# Certificate of Appropriateness

### 1819 N. Hubbard Street, Brewers Hill Historic District

## Date issued 4/9/2024

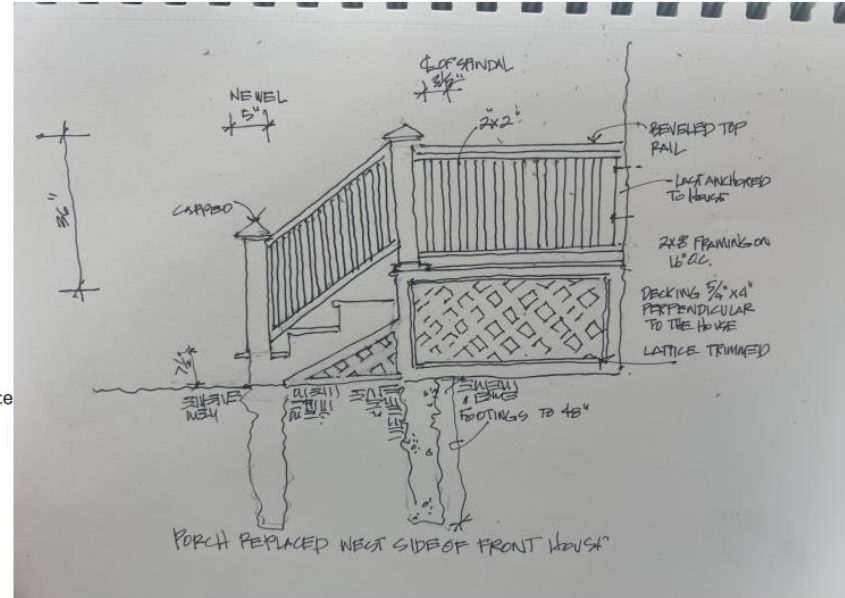
3. Reconnect down spouts to gutter system on north and south sides of rear house

Gutters repaired / replaced and properly connected to down spouts on Rear house north and south and noted.
